Office of Rail Regulation and
Network Rail

**Part A Reporter Mandate AO/026:
Application of CP4 Asset Policies**

Report

Issue 3 | 25 April 2013

Figure 5-2 The B end of the crossover (siding)

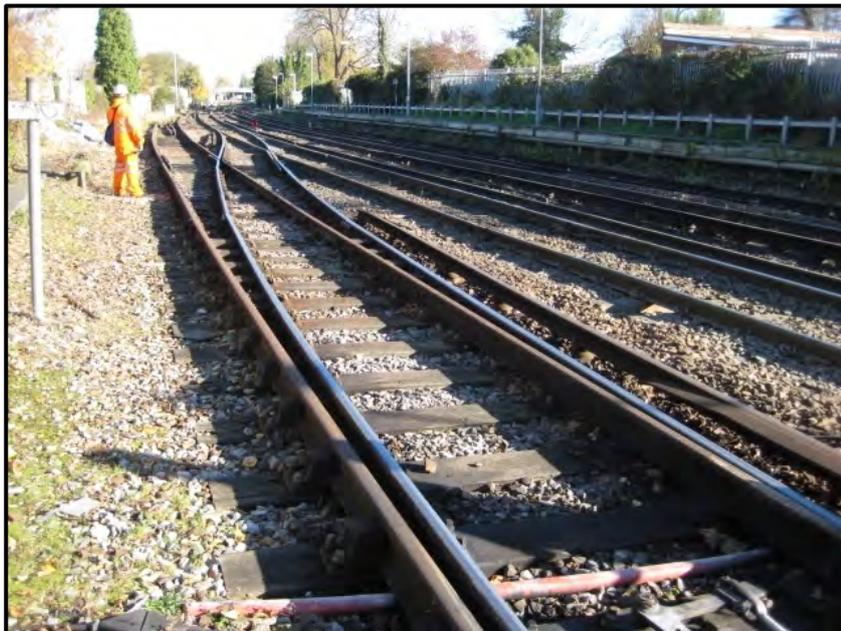
This 3rd rail electrified CV 9¼ crossover was installed in 1976 and allows trains to be berthed in a carriage platform behind the point from which the photograph in Figure 2 was taken. Epsom station is approximately 100 metres in the distance. The line speed on the Up is 60 mph; however there is a 20 mph PSR 80 metres from the tips of 849A points, so the maximum speed can be taken as 30 mph.

Figure 5-7 Replacement timbers in 5A Pts

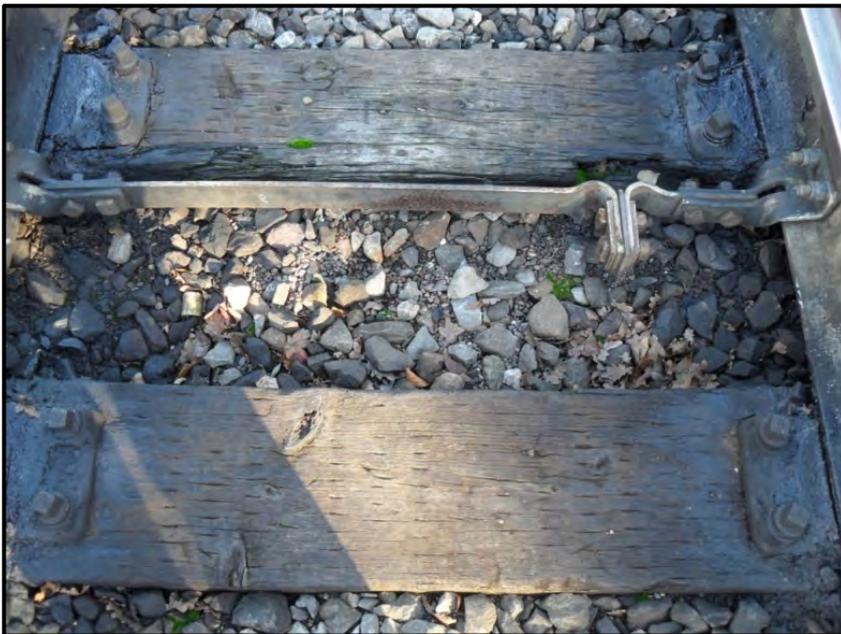
5.5.11 The crossover is inclined 1 in 10 with C switches, installed in 1965. Timbers generally in poor condition (See figure 5-6) with 12 having been replaced. See figure 5-7.

Figure 5-10 Strawberry Hill Double Junction

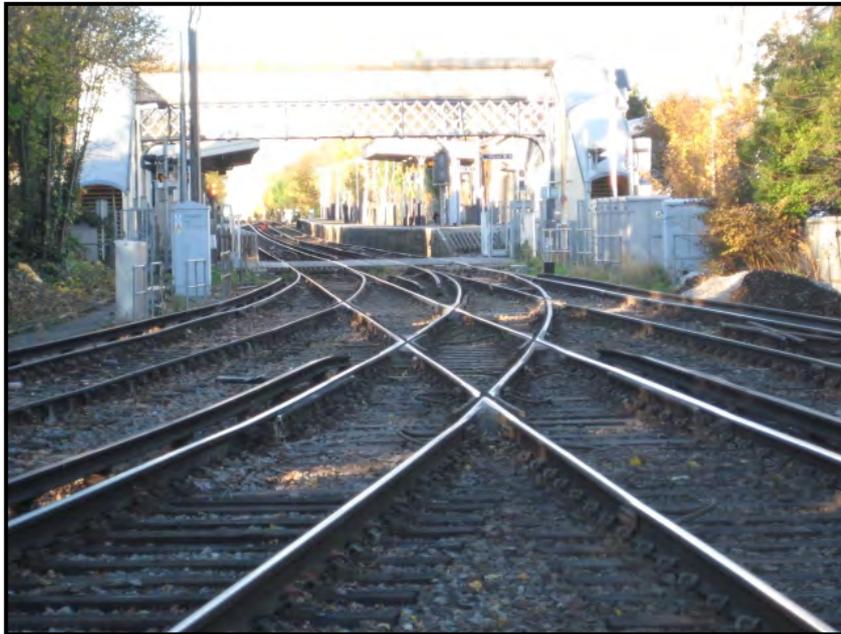
5.5.17 This item is a refurbishment of a double junction and single lead immediately adjacent to Strawberry Hill station and road level crossing. The single lead on the up line is the entrance/exit to Strawberry Hill traction depot. Line speed is 60 mph and the annual tonnage on each track 7 EMGTPA.

5.5.18 The junction was installed in 1970. It is vertical 113lb FB on hardwood timbers with D switches and 1 in 10³/₄ common crossings. The left hand switches of 637 points on the down were changed in 2007. See Figure 5-11.

Figure 5-12 Re-timbering under diamond

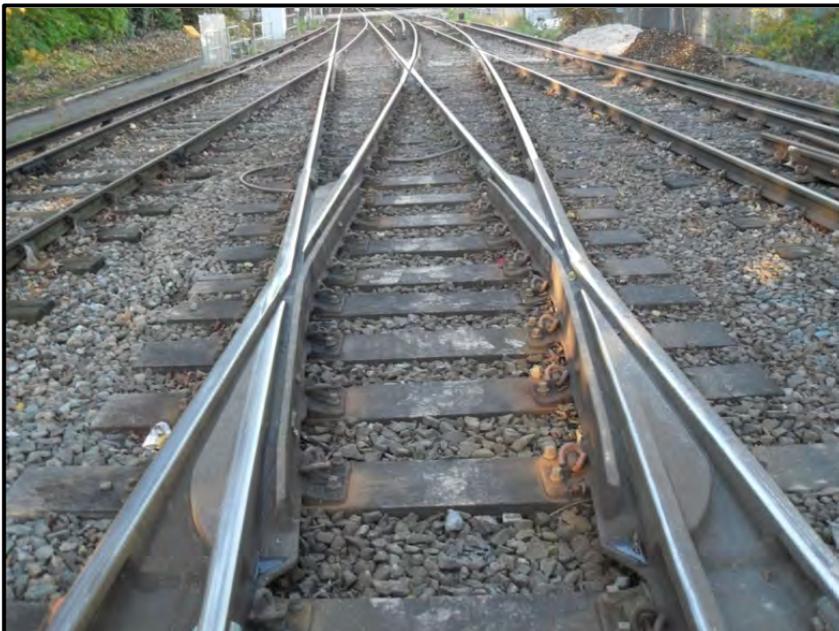
- 5.5.19** The diamond is made up of a 9 ¼ 1975 monoblock crossing with the other 3 units having been renewed most recently in 2009 (2 x 1 in 7½) and 2003 (1 in 6½). Some 20 timbers under and adjacent to the diamond have also been renewed, possibly in 2009. See Figure 5-12. Gauge in the diamond was good.

Figure 5-26 Pan 11 baseplate replacement for Pan 8. (Note that the rail is one of two 60ft lengths replaced in 2009.)

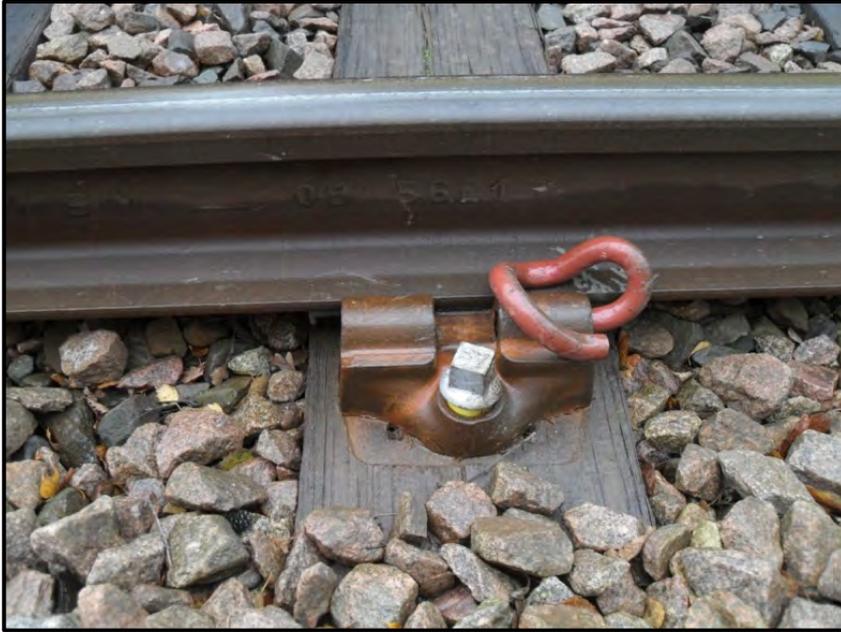
5.5.36 Work was in progress to replace the Pan 8 baseplates with Pan 11s utilising the existing sleepers (see Figure 5-26). Fresh ballast had been unloaded in preparation for the full refurbishment item which would include completing the exchange of baseplates and renewing the jointed track with new rail welded up to form CWR.

Fig 5-29 Down main Starcross Station looking towards London

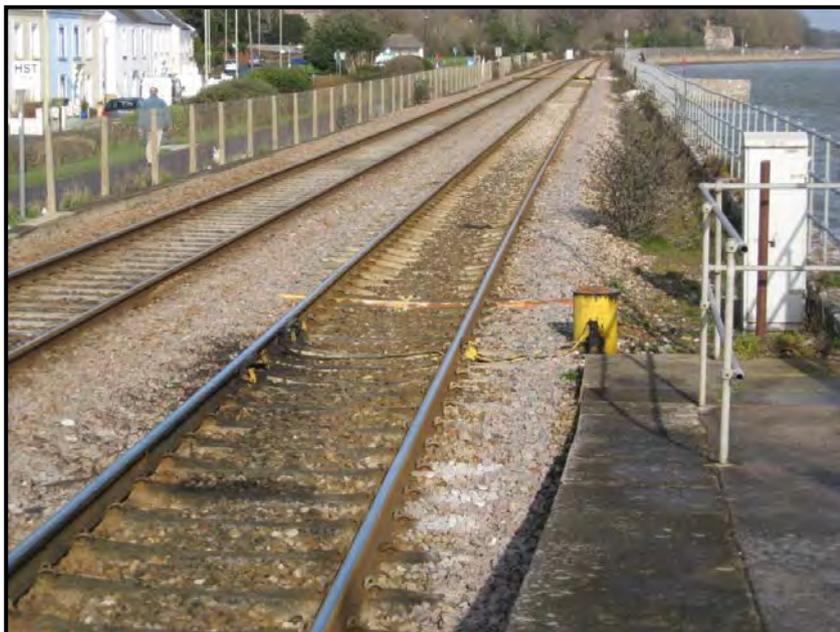
- 5.6.7** The proposal at Starcross was originally put forward in 2007 to totally renew the Down Main over 550 yards due to poor ballast conditions (manifesting as very poor 'top' or vertical geometry) in 2012/13. The track is 113lb CWR on EF23 sleepers with pandrol fastenings and was installed in 1971. It carries 10.1 EGMTPA at a line speed of 75 mph and rail and sleeper condition are good. Therefore in October 2011 this item was specified for refurbishment (ballast renewal) in 2013/14. It has since been deferred to 2014/15 due to delivery difficulties in 2013/14. The preferred method of ballast renewal is by high output ballast cleaner however at Starcross the proximity of the sea wall adjacent to the Down Main prohibits this type of operation. The alternative solution considered was the RailVac ballast cleaner.

- 5.6.8** The cost quoted by the operator of the RailVac plant to undertake this work was £350,000 which is approaching the cost of a complete track renewal, therefore making the RailVac method unattractive to the RAMT despite it offering the best engineering solution - the key advantage of the RailVac is that the reballasting can be undertaken with the rail in situ therefore the rail does not need to be cut.

Fig 5-31 Newton Abbot West Jcn (associated drainage survey with 942 points crossover to the left side of the diagram)

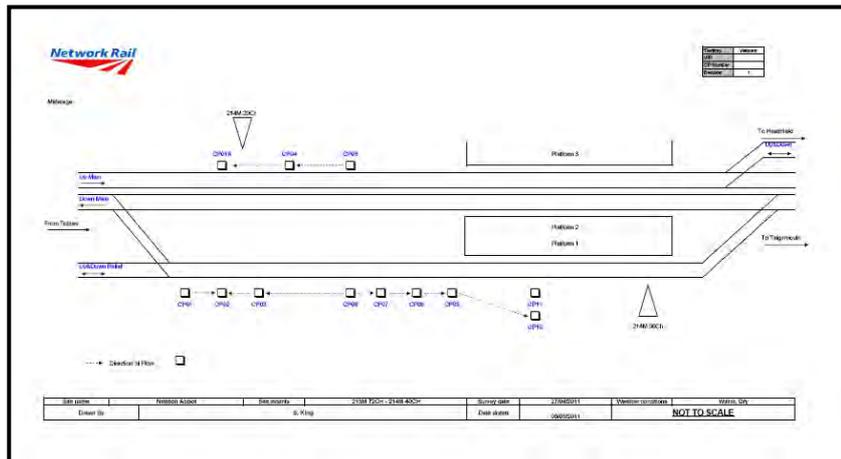
5.6.17 Newton Abbot West Junction comprises four crossovers to the west of the two platform station and forms the junction where the Totnes line diverges away from the main line to Plymouth. Installed in 1984 and 1986, the four crossovers are 113lb FB vertical with cast crossings and full depth switches, on hardwood timbers. As nearly all trains stop in Newton Abbot, main line speeds are less than the published 60 mph PSR, and annual gross tonnage is in the region of 10 million.

5.6.20 Whilst the resulting outcome of the drainage survey was a relatively small work item, the importance of associating proposals for track renewal with associated drainage has been recognised. An initiative to review and inspect an important junction approaching 30 years of life has resulted in a specification for refurbishment which should provide a further 15 years of asset life before the next major intervention and is compliant with Policy 10 Refurbishment.
